From: Michael Eastham
Sent: 29 September 2017 12:39
To: Planning.Responses
Subject: FW: Stage 1 Road Safety Audit - Development proposals at Land adjacent to Water Lane, Angmering

ROAD SAFETY AUDIT RESPONSE REPORT

A280 / A27 / TITNORE LANE ROUNDABOUT PROPOSED IMPROVEMENTS ROAD WIDENING OPTION

STAGE 1

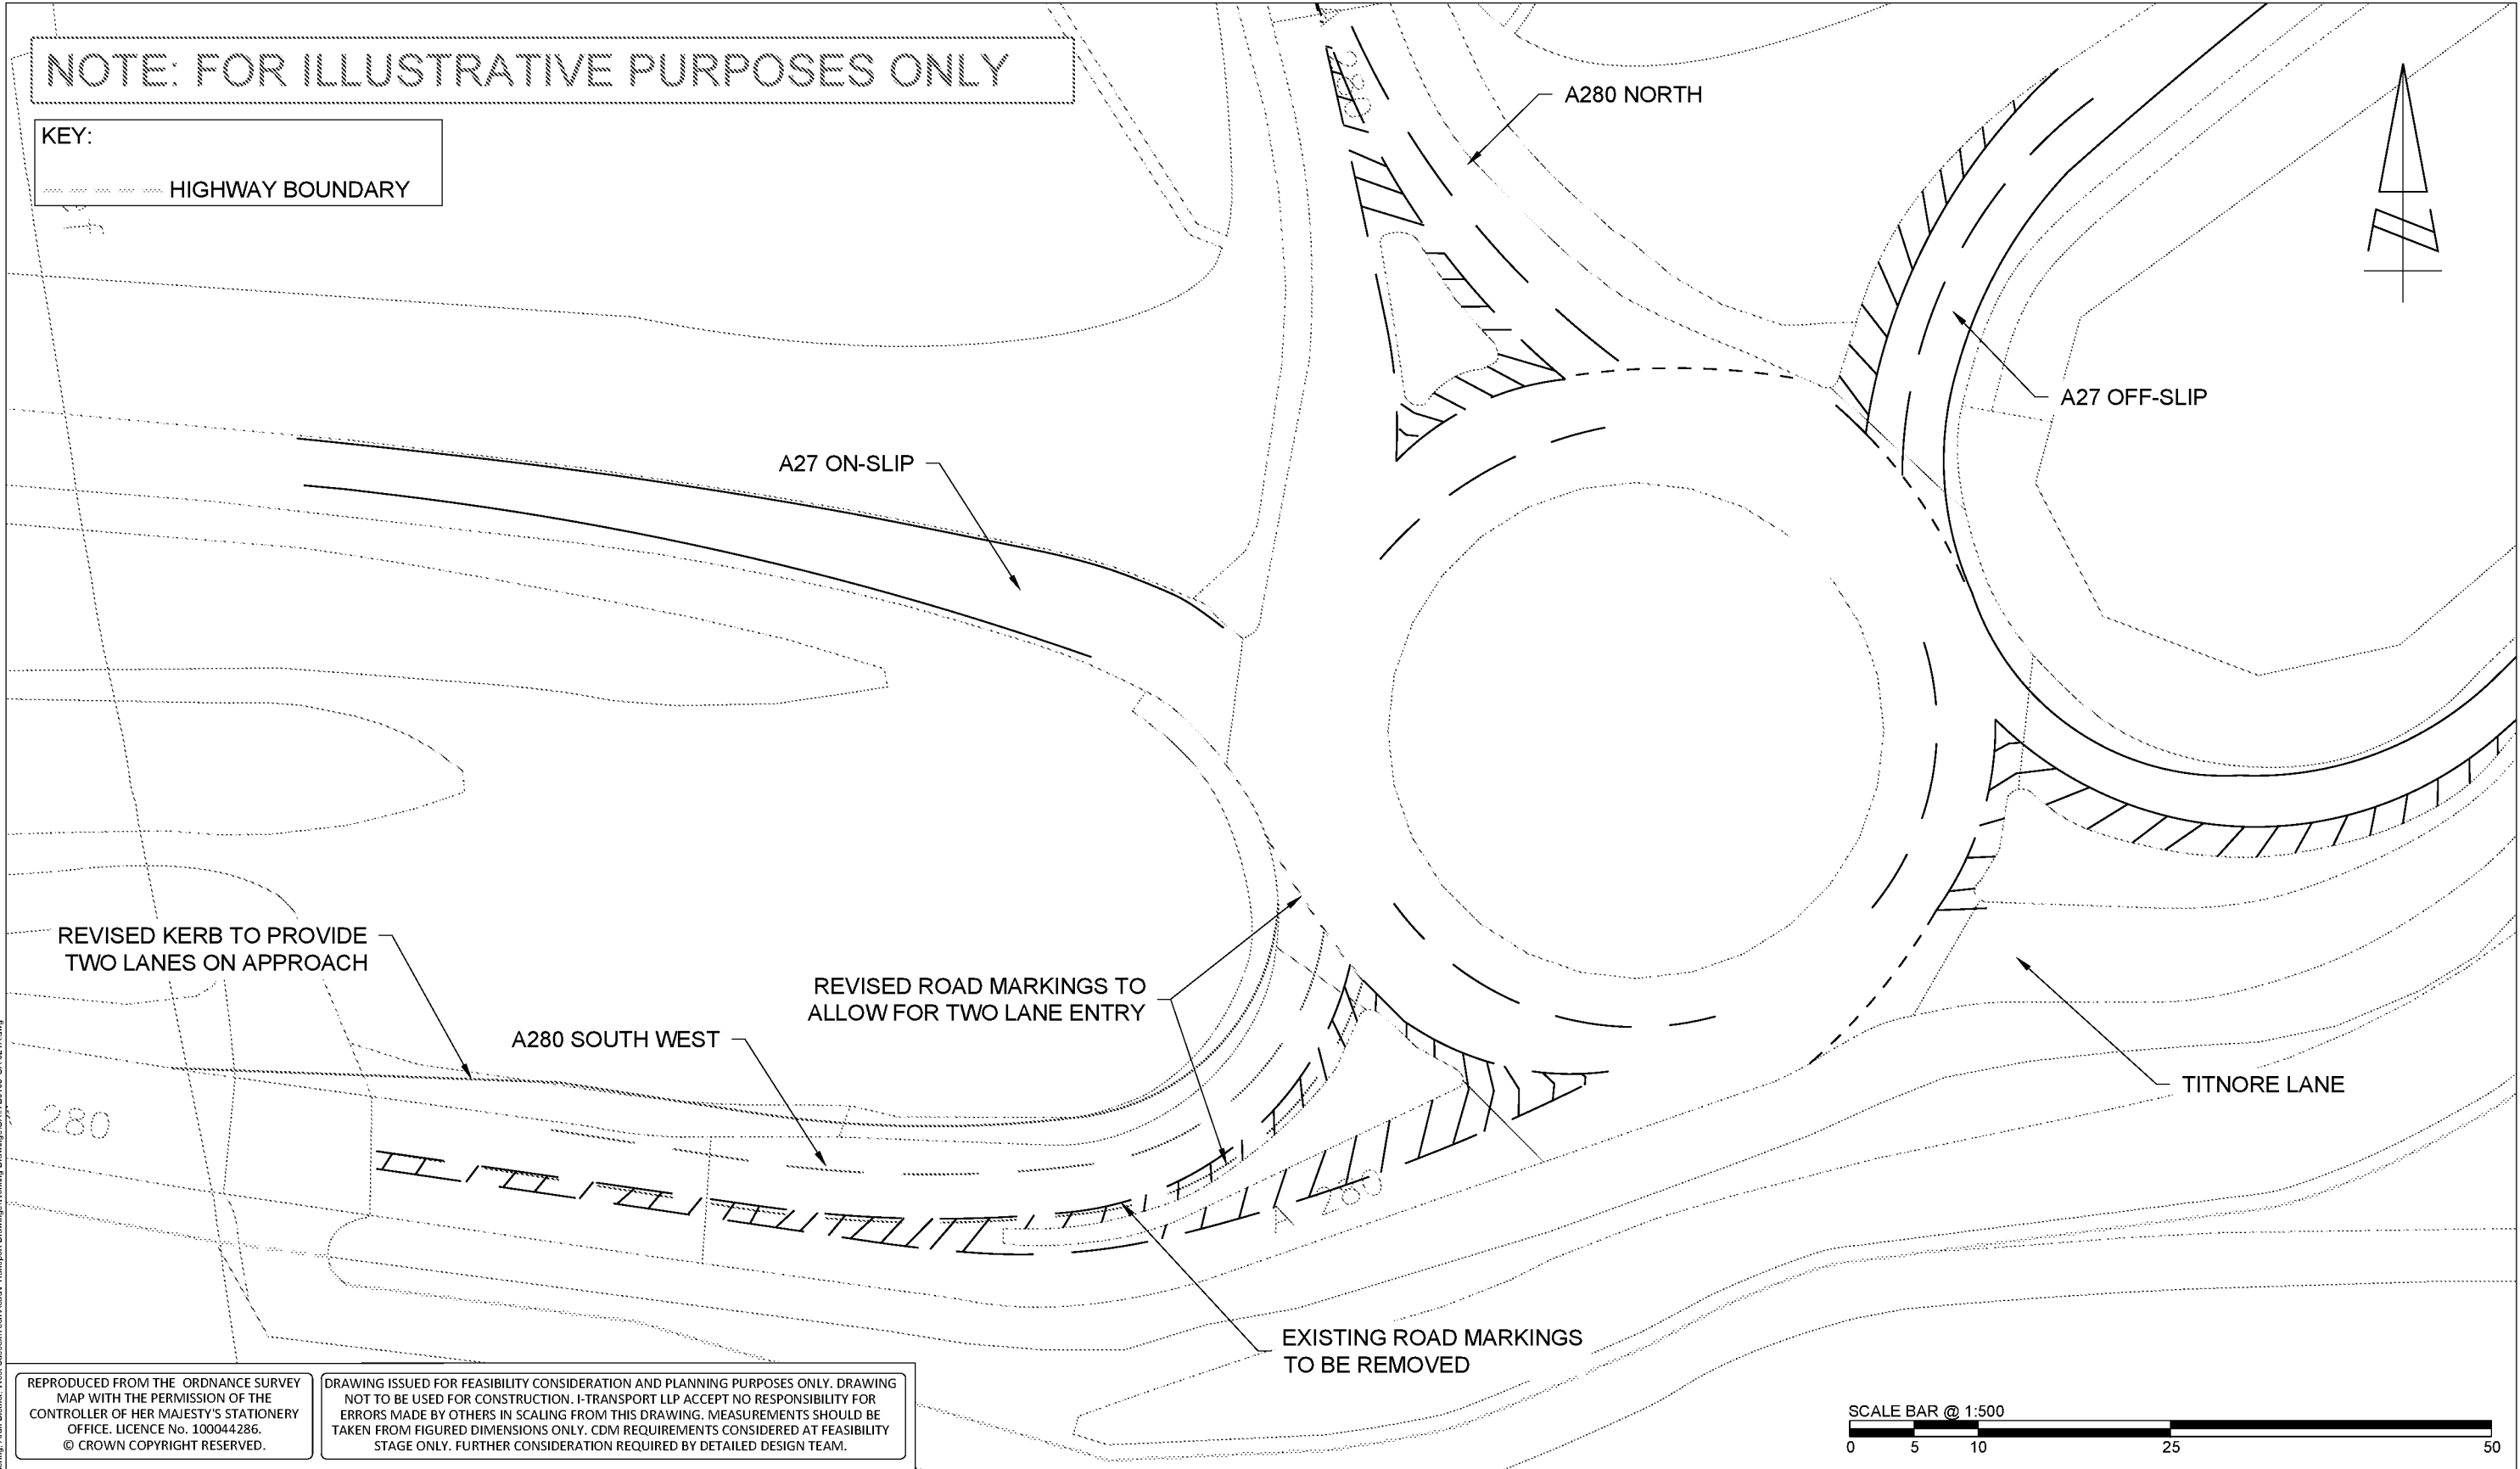
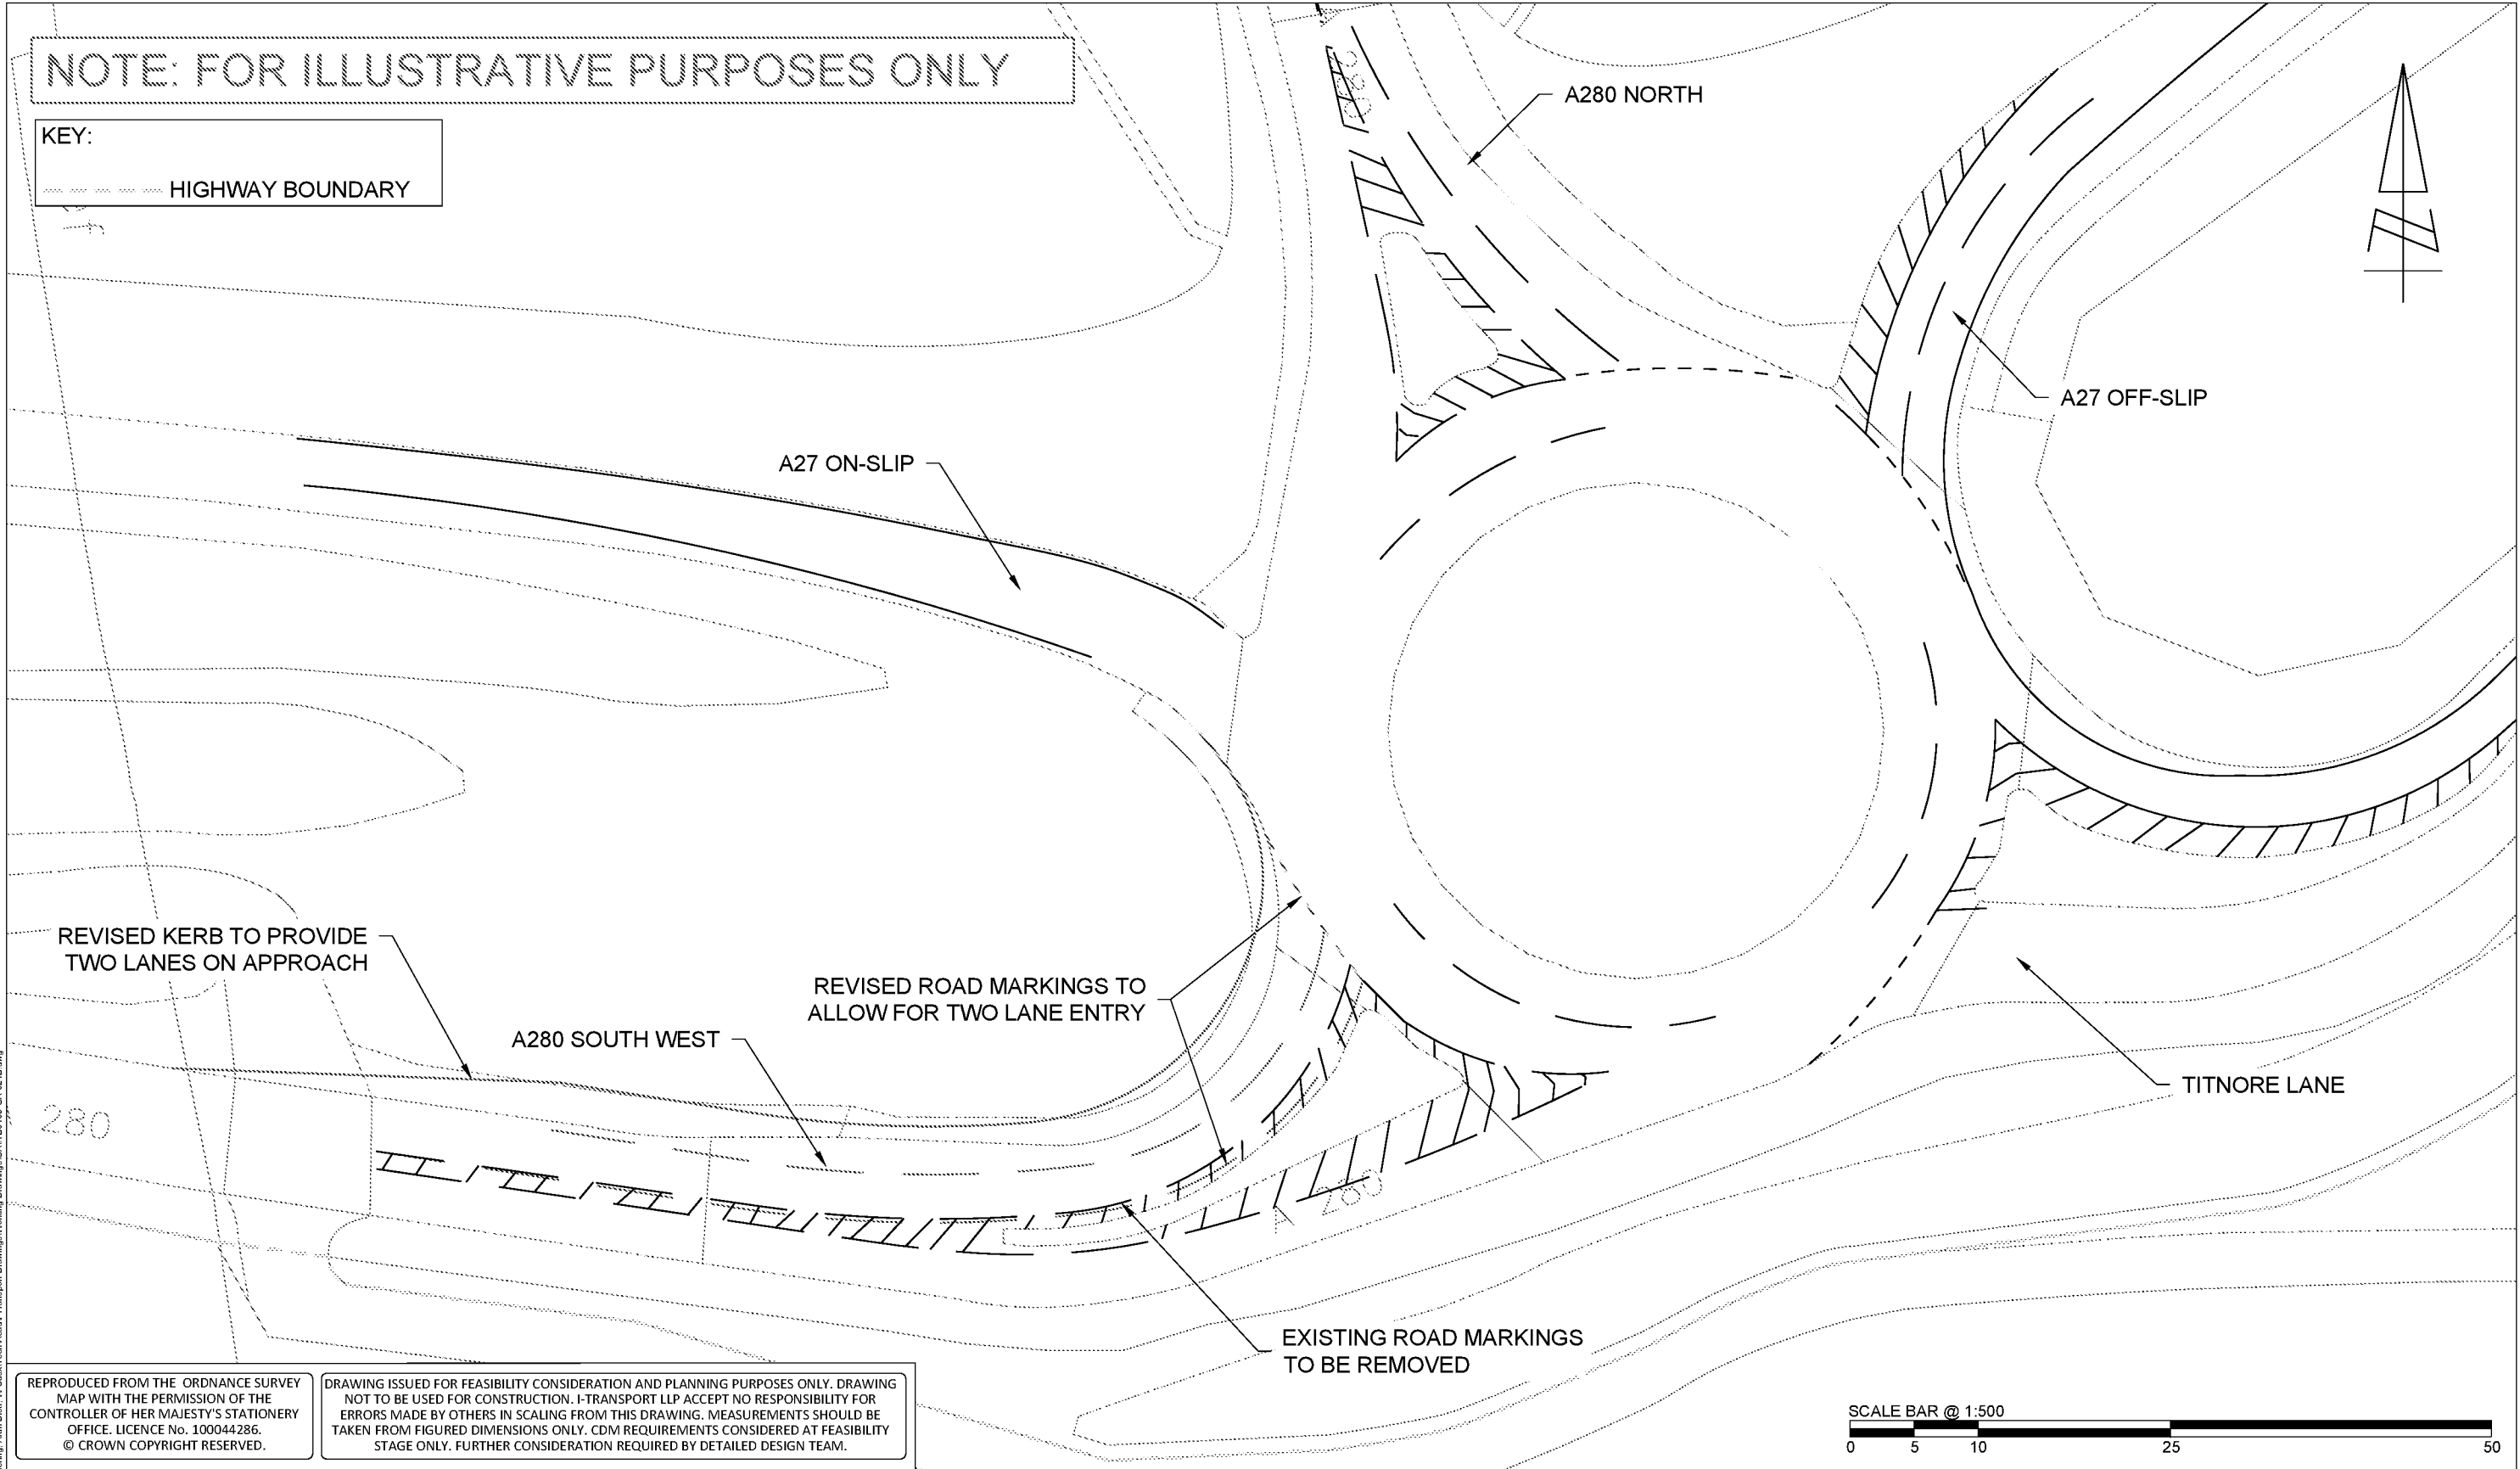
3.3.1 PROBLEM

Location: A280 Water Lane approach to roundabout.

Summary: Risk of overtaking vehicles striking articulated HGVs.

The proposed widening scheme will allow cars and other smaller vehicles to access lane two on the approach to the roundabout alongside articulated HGVs in lane one. The swept path analysis shows HGV's will require to enter lane 2 when positioning themselves on the approach to the roundabout in order to access the first or second exits from the roundabout. This will increase the risk of side swipe type collisions or vehicles in lane 2 having to brake heavily risking tail end shunts when the HGV swings into lane two to manoeuvre for access.

The widening should be reduced the on the approach such that other traffic is not provided with an opportunity to gain access to lane two prior to articulated HGVs taking up position on approach to the roundabout. Alternatively, the entry should be realigned to allow cars to pass safely.

Agreed – To reduce the risk of side swipe type collisions the approach has been realigned to allow cars to pass an HGV's safely. This has been provided on Drawing ITB9105-GA-024 Rev B. Swept path analysis has been undertaken to demonstrate that a car can pass an HGV safely as illustrated in Drawing ITB9105-GA-035 Rev A.
